**MSOX4024A-01**

**S E R V I C E N O T E**

4000 X-Series Scopes

**A replacement of the power supply cover is needed when the cabinet assembly is replaced.**

New revision cabinet assembly (54709-64401)

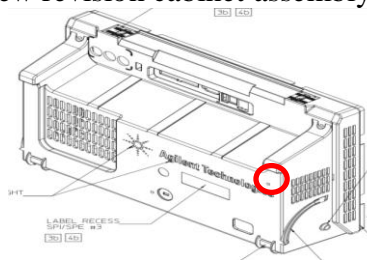
1. If the cabinet assembly (54709-64401) needs to be replaced, check if it is the old revision or the new revision
  - a. Old revision has 3 screw holes
  - b. New revision has 4 screw holes

2. If the cabinet assembly is the new revision, proceed with repair as normal
3. If the cabinet assembly is the old revision
  - a. Replace the power supply cover (54695-00103) with new revision
  - b. Replace cabinet assembly as usual (54709-64401)
  - c. Insert screw (0515-0380) into the new screw hole on the cabinet assembly (circled below)
